# Modification 1 of Advanced Manufacturing Research Facility (AMRF) Building 2

State Significant Development Modification Assessment Report (SSD-58591961-Mod-1)

April 2026

Figure 5 | Basement 2 Layout Plan

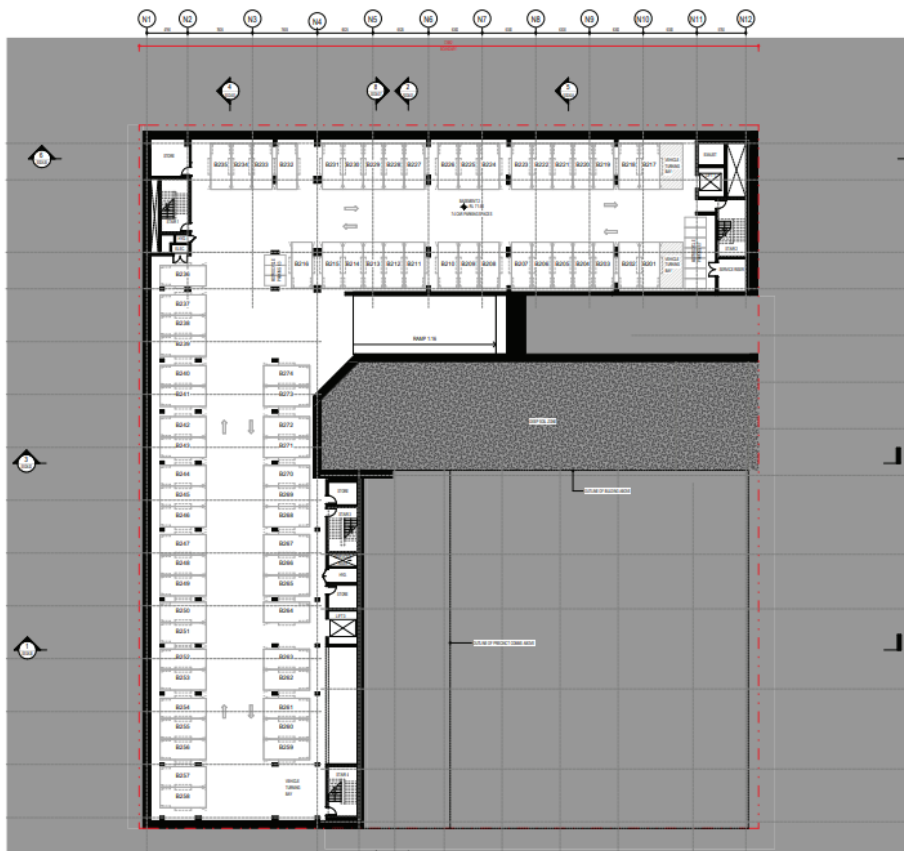
Basement 2 removed

**Figure 6 |** Basement 1 Layout Plan

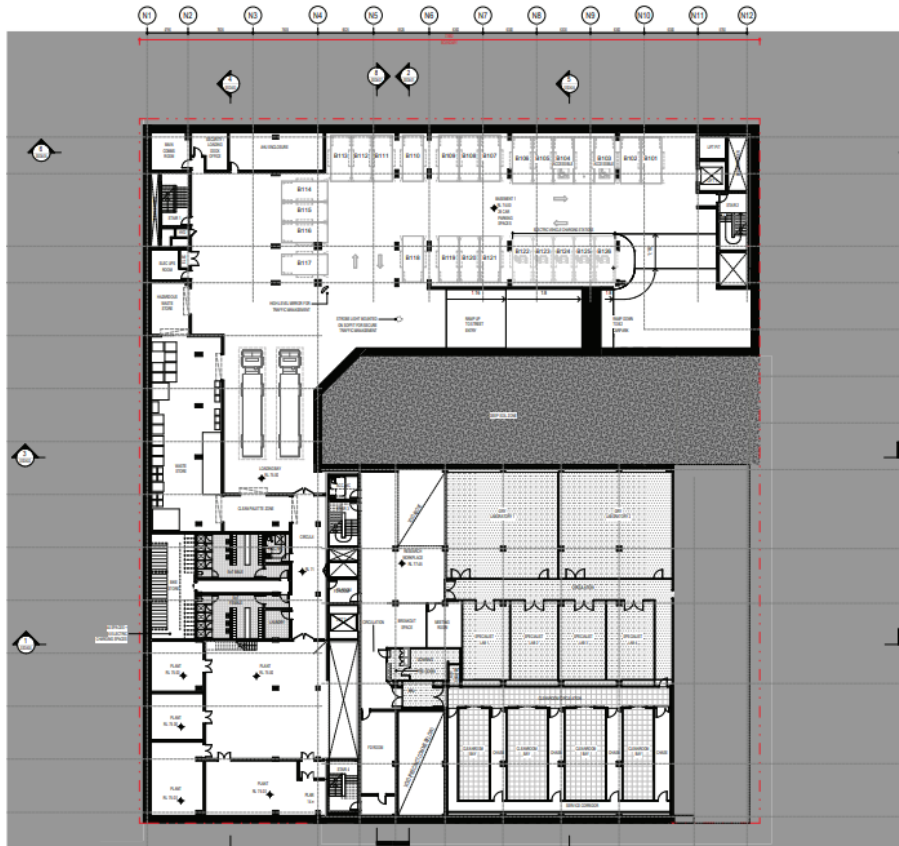
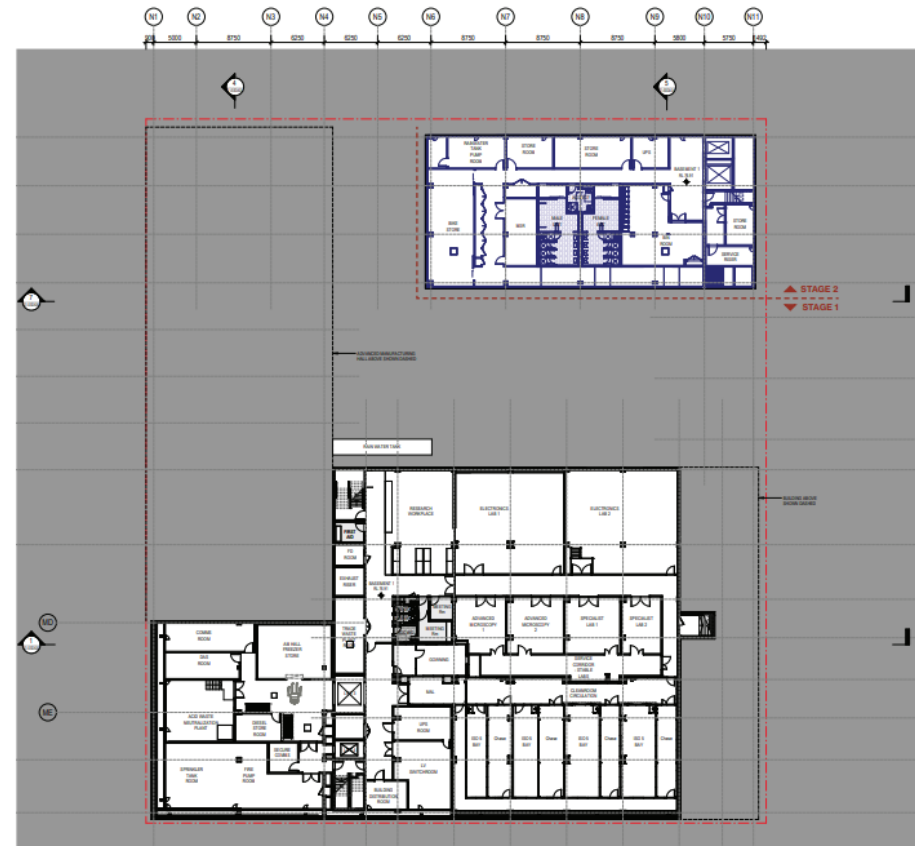
- Stage 1**
- Plant & BOH
  - End of Trip facilities (to be relocated in Stage 2)
  - Research Laboratories
  - Loading Bay relocated to Ground Floor

- Stage 2**
- Plant & BOH
  - End of Trip facilities (relocated from Stage 1)

**Figure 7 | Ground Floor Layout Plan**

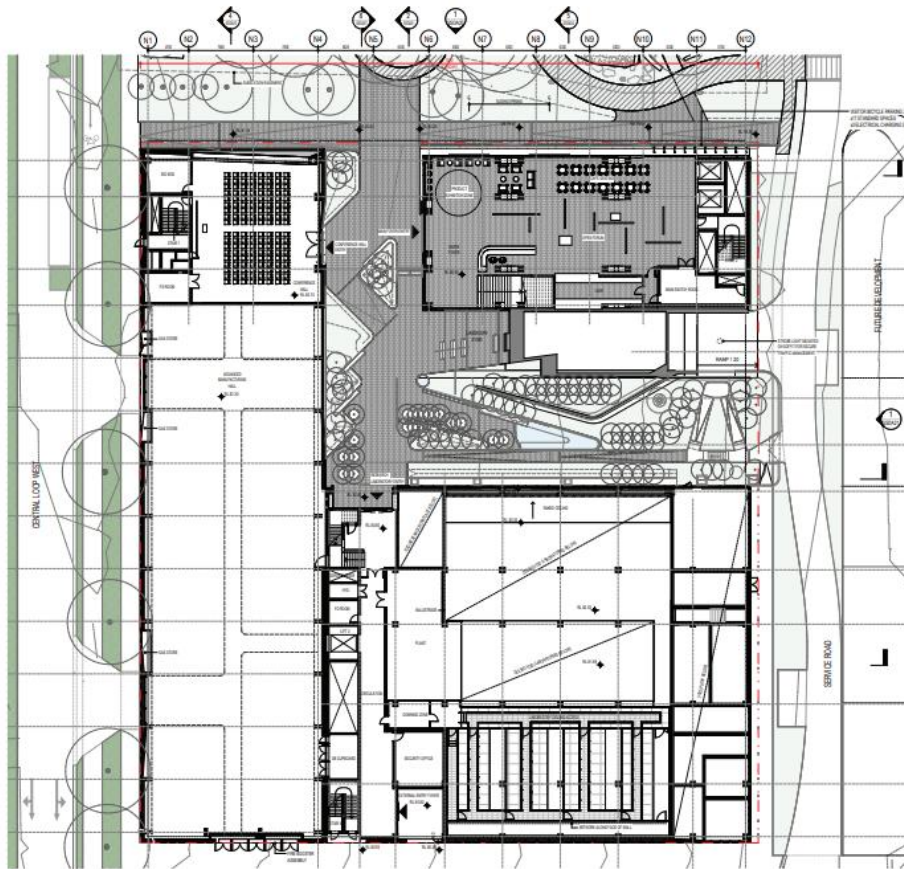
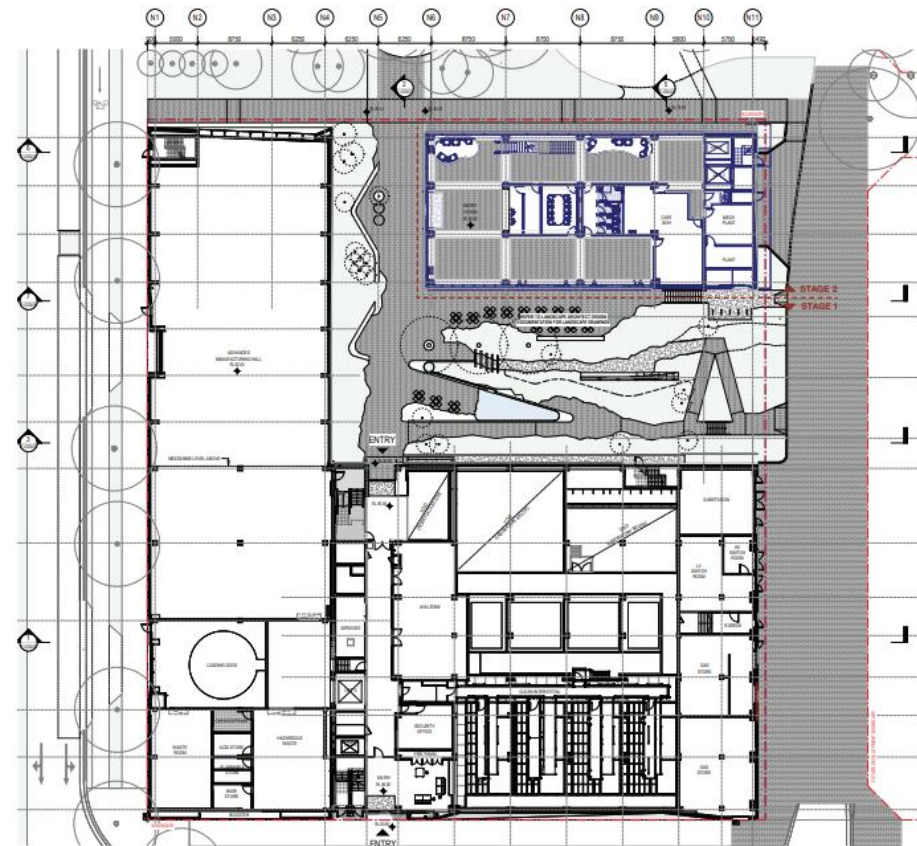
- Stage 1**
- Advanced Manufacturing Hall
  - Loading Bay
  - Courtyard
  - Research Laboratories
  - Substation & Gas Storage

- Stage 2**
- Conferencing Facilities relocated to Level 2
  - Main Entry Foyer
  - Cafe

Figure 8 | Level 1 Layout Plan

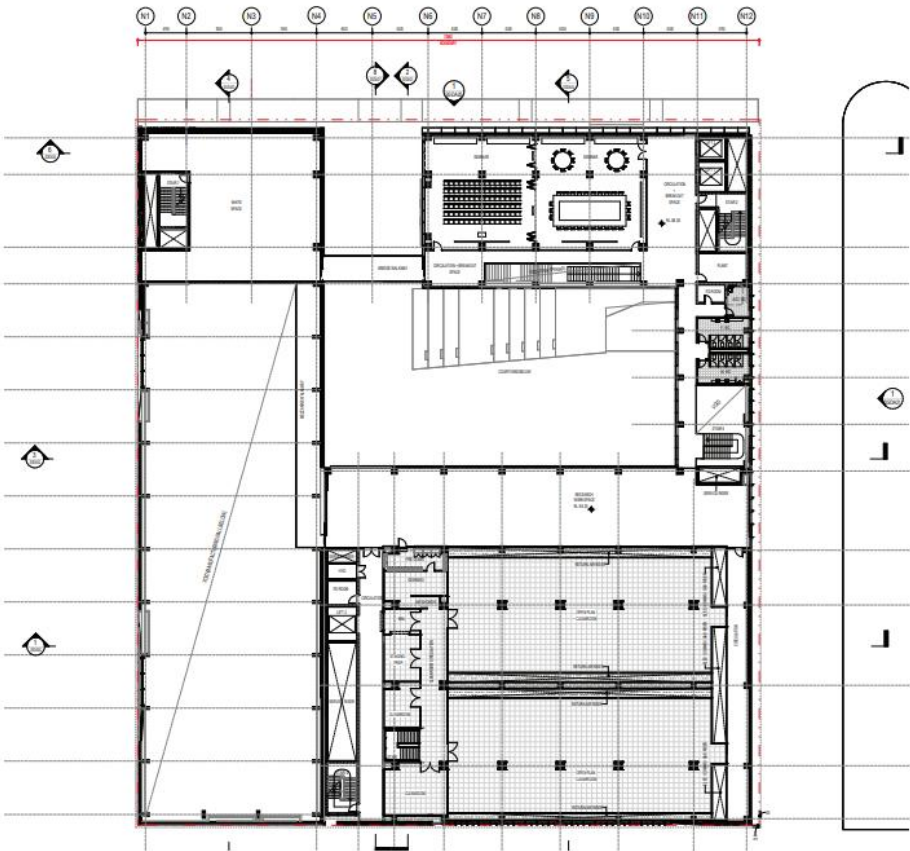
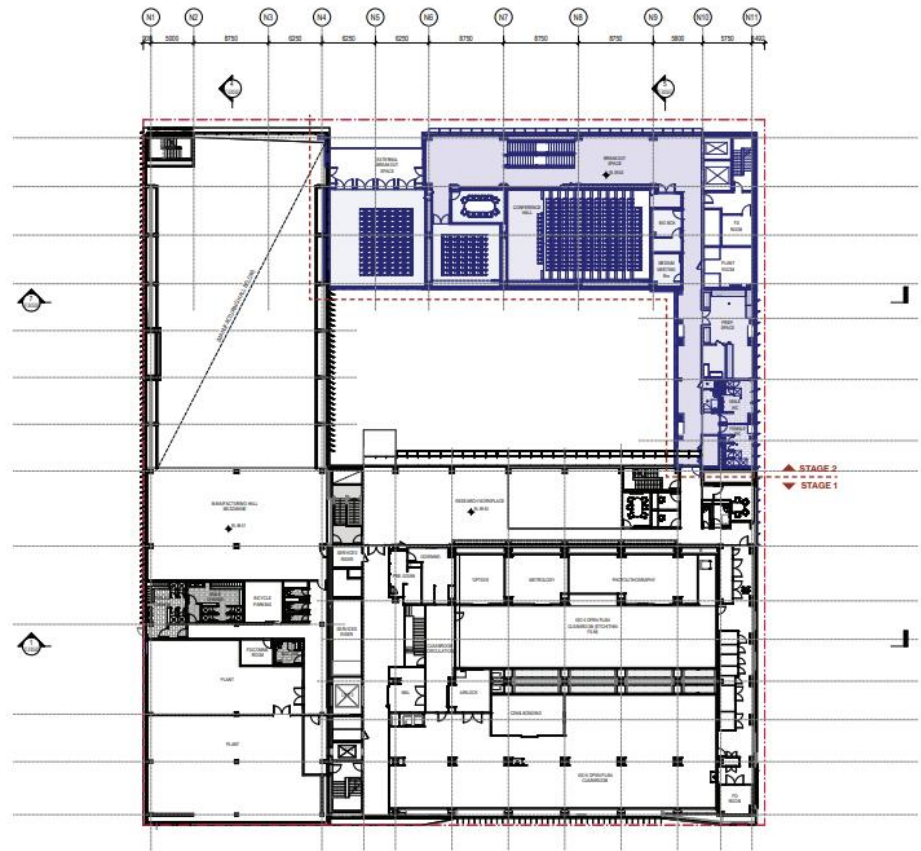
- Stage 1**
- Research Workplace
- Research Laboratories
- Plant relocated from Basement

- Stage 2**
- Conferring Facilities relocated from Ground Floor
- Seminar Facilities

**Figure 9 | Level 2 Layout Plan**

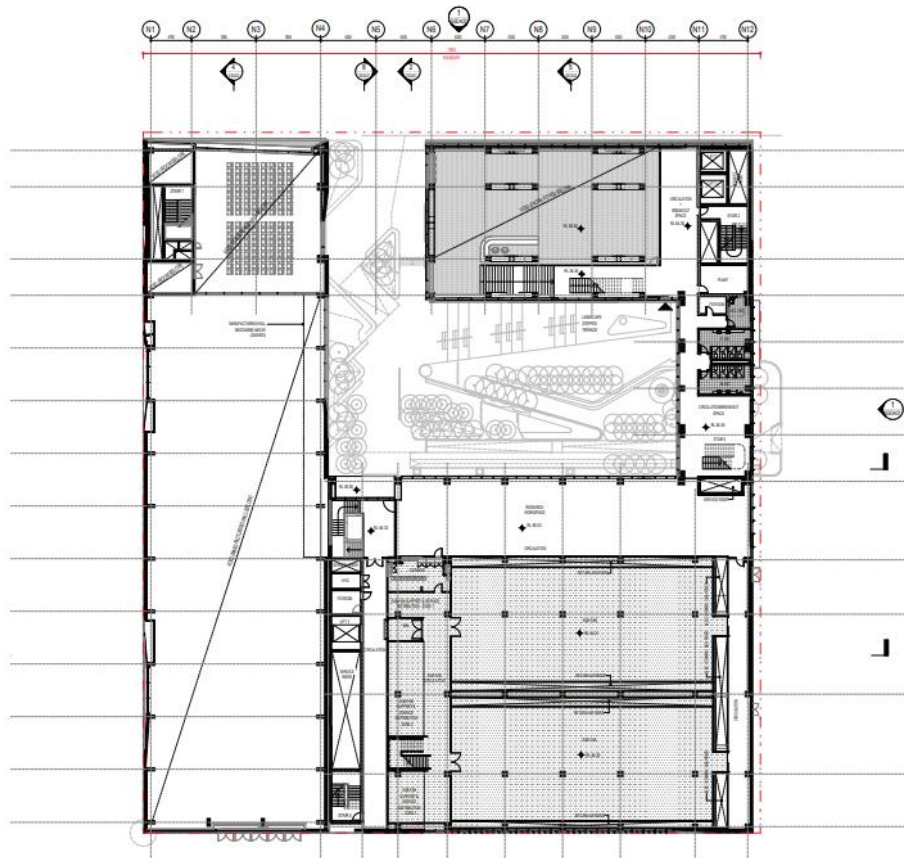
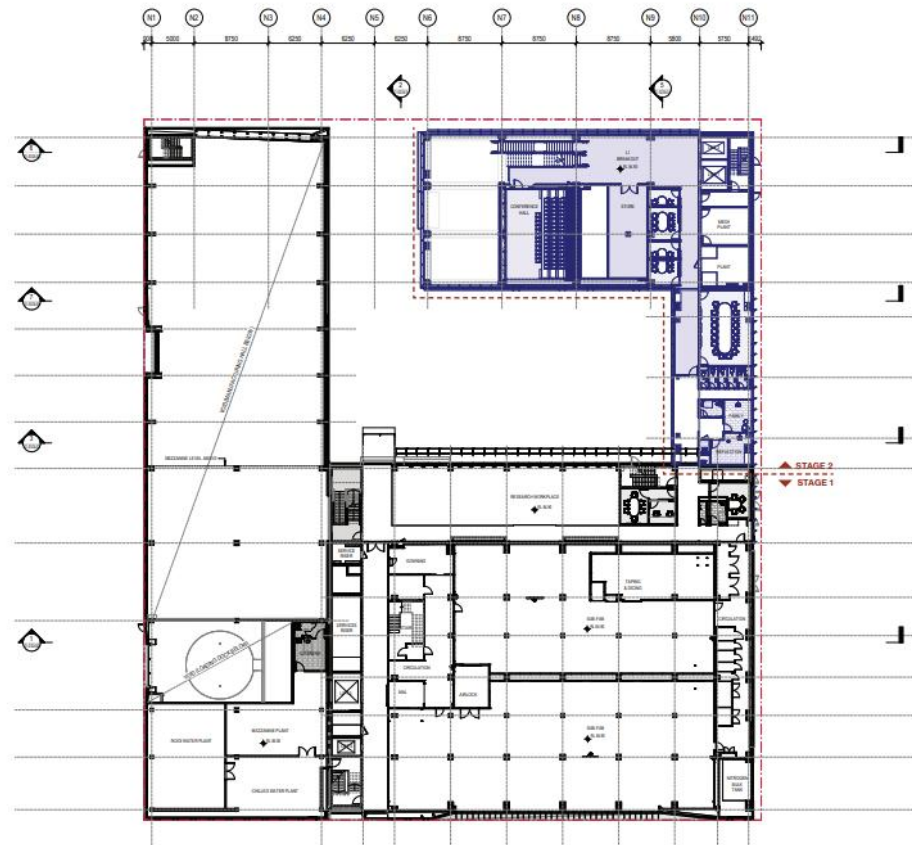
**Stage 1**  
Research Workplace  
Research Laboratories  
Plant relocated from Basement

**Stage 2**  
Conferencing Facilities relocated from  
Ground Floor

Figure 11 | Level 4 Layout Plan

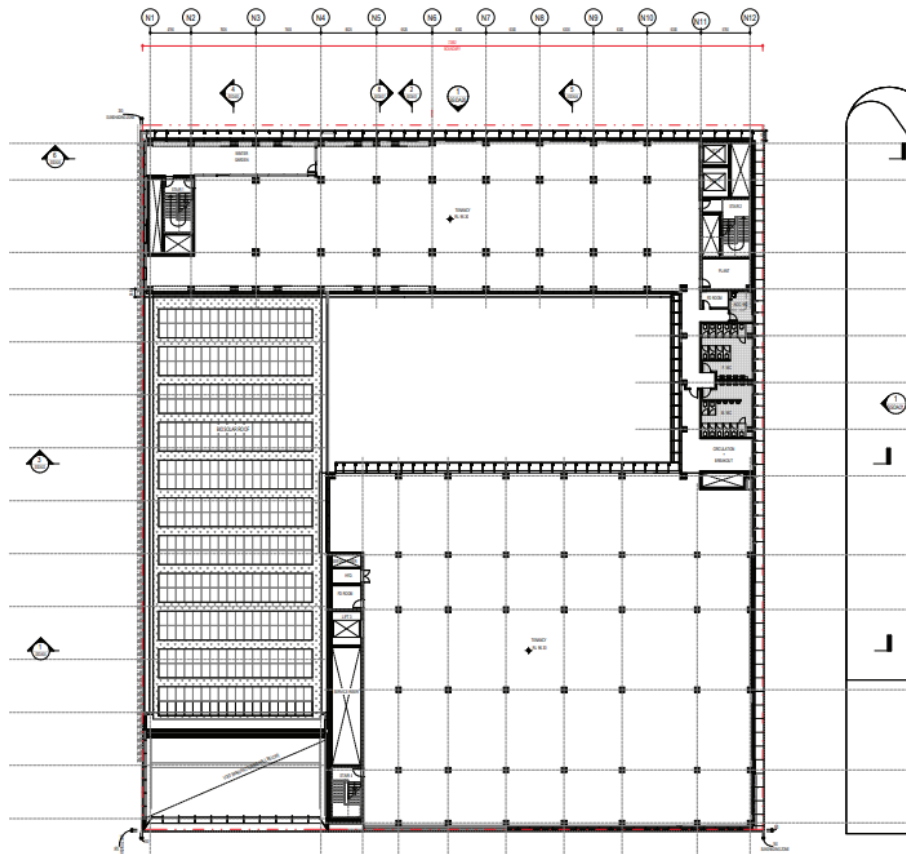
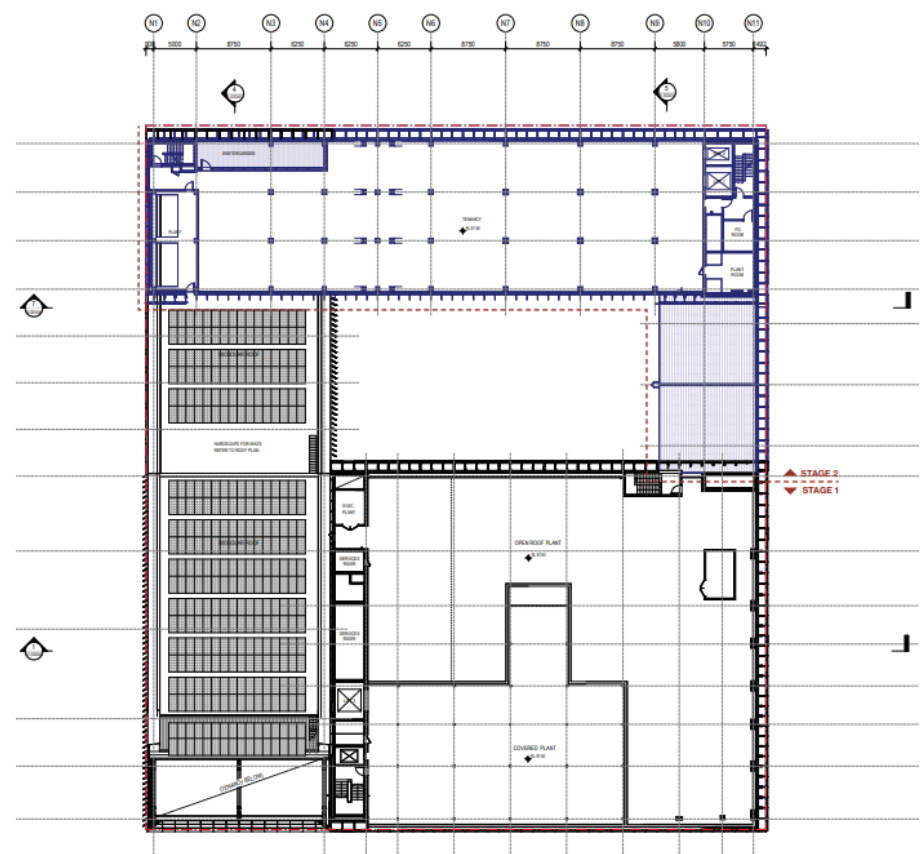
Stage 1  
Biosolar Roof  
Plant

Stage 2  
Tenancy reduced

Figure 13 | Central Courtyard Layout

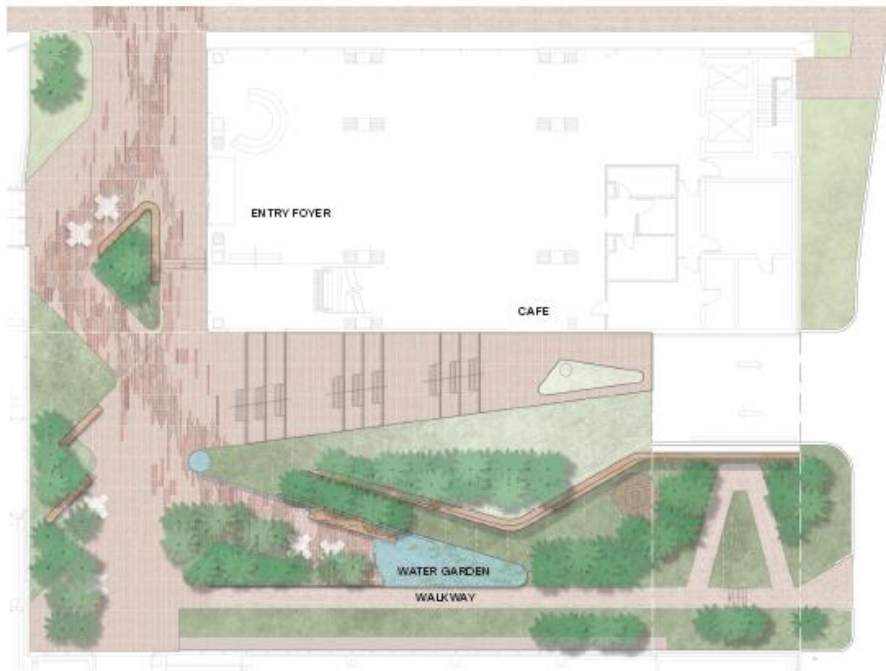
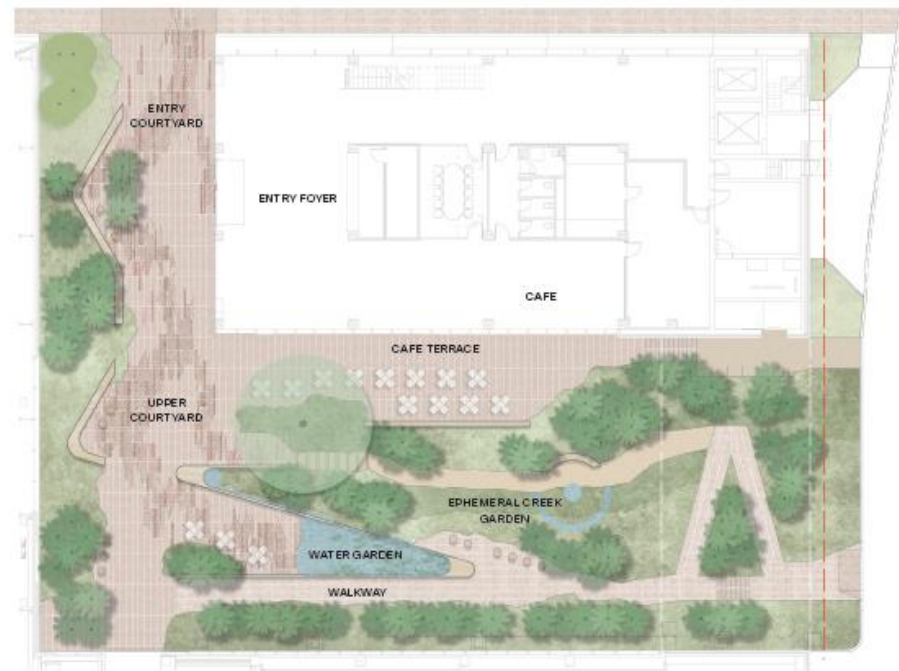
Stepped terraces deleted with removal of basement ramp, grading flattened across the courtyard.

Stepped terraces replaced with flat cafe terrace and cafe seating.

Rammed earth retaining wall removed, introduction of additional path through Ephemeral Creek Garden.
